Re: Sixth Review of Notice of Intention to Commence Large Mining
Operations, Unico Incorporated, Deer Trail Mine, M/031/003, Piute
County, Utah

**SIXTH REVIEW OF NOTICE OF INTENTION TO
COMMENCE LARGE MINING OPERATIONS**

**Unico Incorporated
Deer Trail Mine**

**M/031/003
October 26, 2004**

Unico - Deer Trail Mine
General Mine Permit Area
M/031/003

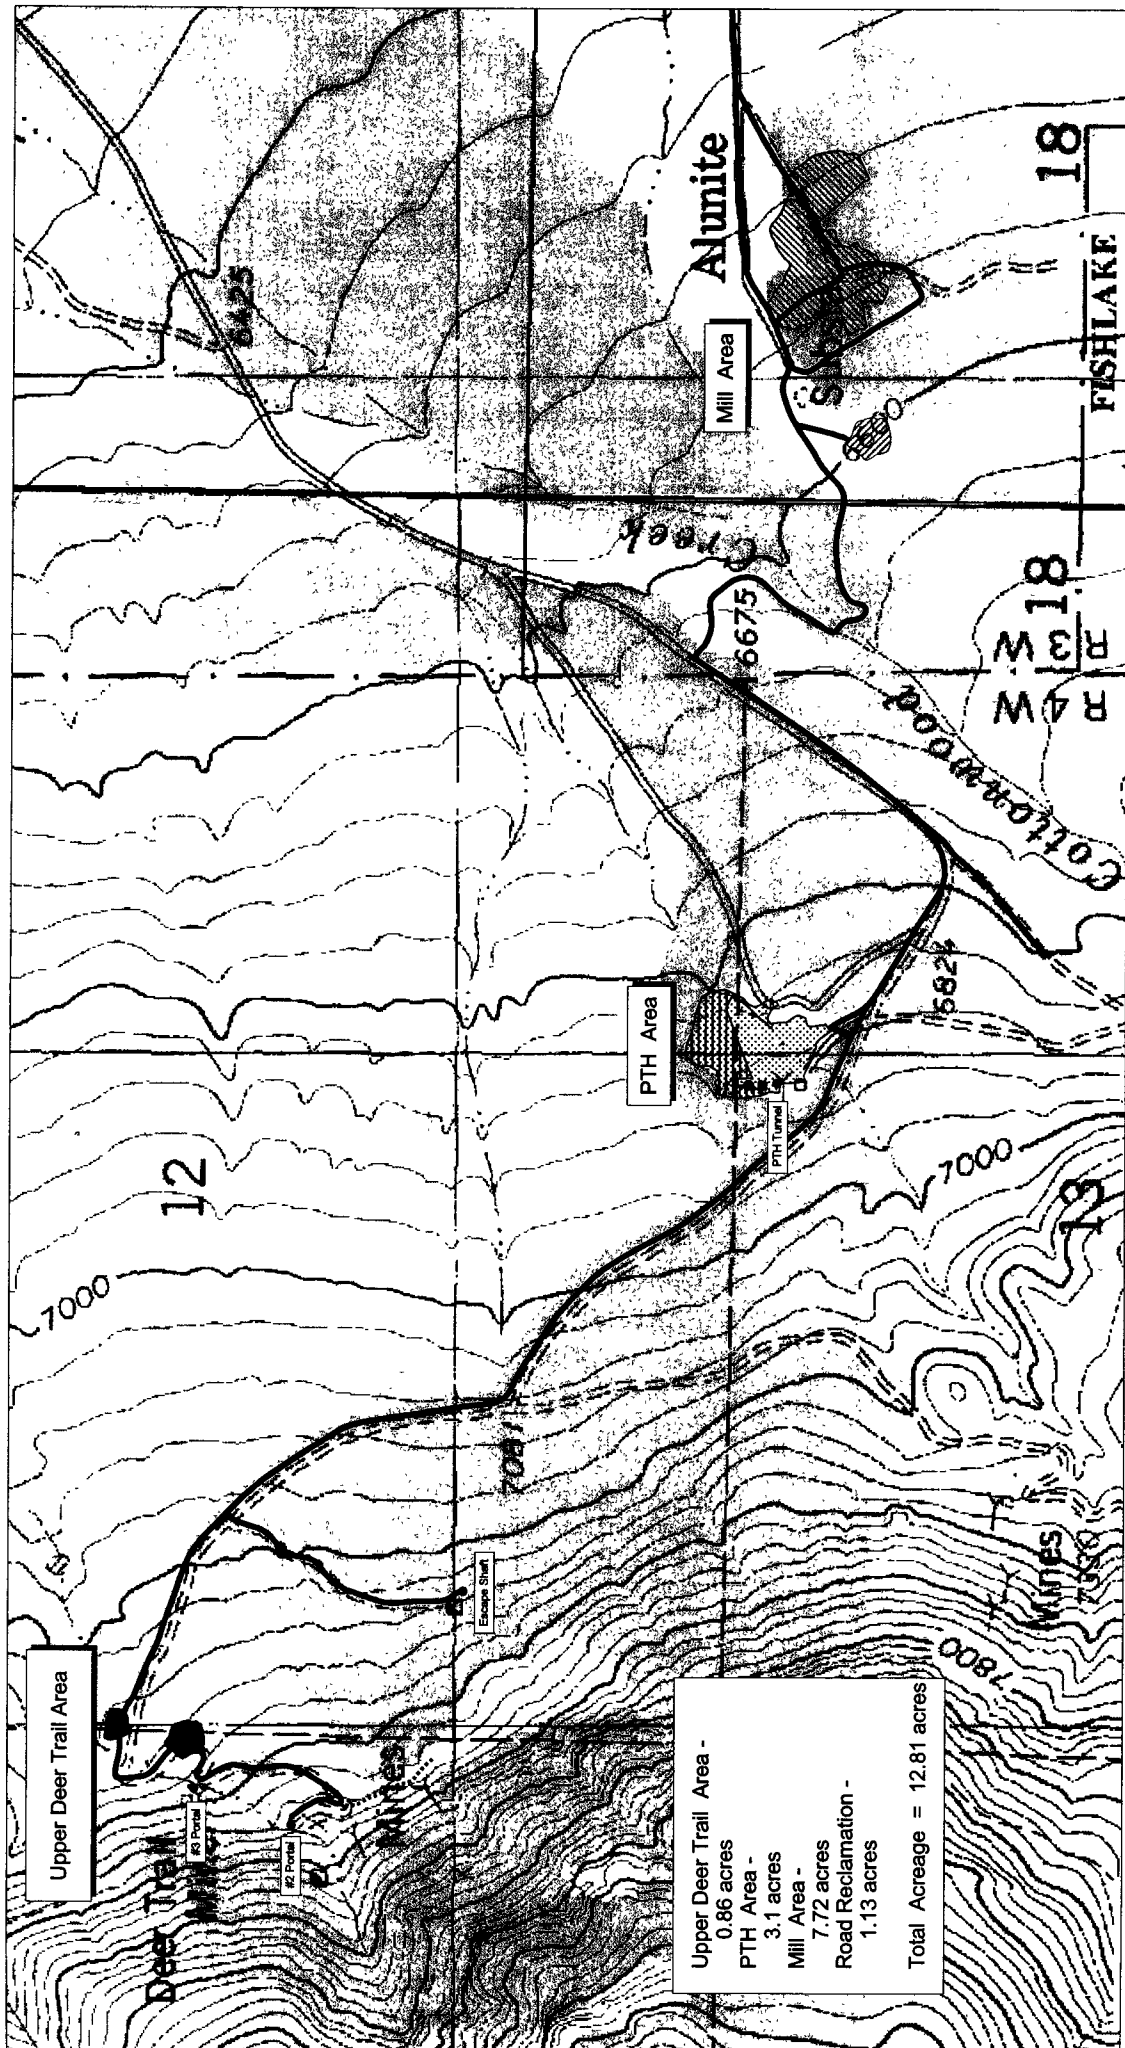
Attached to this review are a series of maps produced by the Division that show the extent of current disturbance associated with this operation. Acreage determinations were based on GPS survey data. A total of 12.81 acres have been included in the disturbed acreage (this includes 0.31 acres of pre-existing roads within the Mill area disturbance that will not require reclamation). Please use these base maps, or at least provide the information from these maps on base maps you have generated. (LK)

Current disturbed acreage is shown on the attached maps. In summary, the Upper Deer Trail area includes a dump and screening area (total of 0.86 acres). The increased width of the access road from the PTH area to the Upper Deer Trail area is 1.0 acre. The PTH area is 3.1 acres (there is an additional 2.3 acres of disturbance which is not included in the permit that includes the grandfathered (pre-existing) dump area and areas associated with fire suppression activities created during a recent forest fire in the area.). The Mill area includes 6.99 acres (which includes 0.31 acres of pre-existing road which will not require reclamation), the fresh water pond (0.73 acres) and access to the pond (0.13 acres). This shows a total of 12.81 acres currently associated with this operation, of which 12.5 acres will require reclamation treatments. If there is any additional area that will be added to the permit, please identify these areas. (LK)
